01 - 2010
BDF453 / BDF453Z / BDF453H
18V 1/2" DRIVER DRILL

SERVICE CHANGES

1. Changes on Switch, Terminal, and Housing Set (Battery Protection Circuit)

(T/I# 93856)

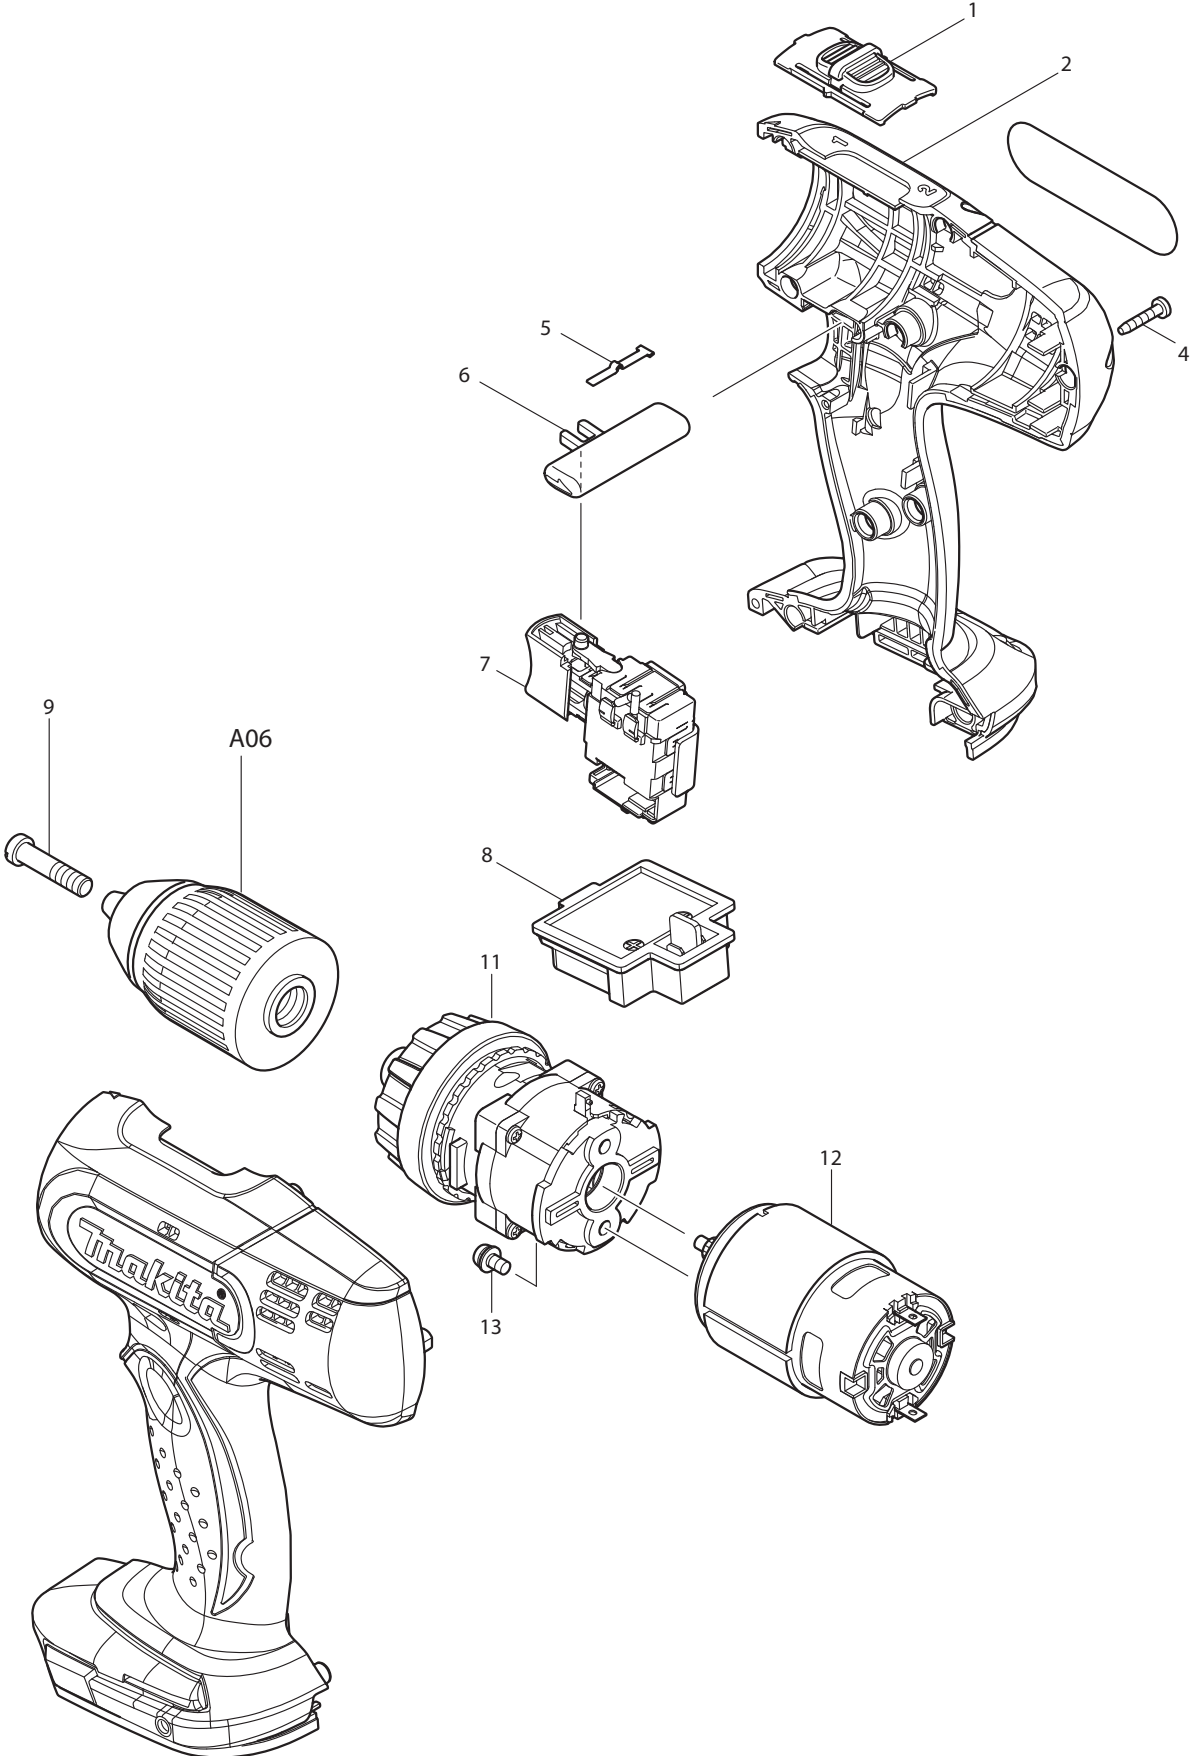
Item No.	Description	Type 1	Type 2	Type 3
2	HOUSING SET		188542-5	187363-2
7	SWITCH		650604-4	632A24-0
8	TERMINAL	643812-4	643844-1	643852-2

Above parts are completely interchangeable as a set.

- Use new parts for repair of the model manufactured on or after December 2011 with using Yellow lead wire between Switch and Terminal.
- Use current parts for repair of the model manufactured before December 2011 without using Yellow lead wire between Switch and Terminal.
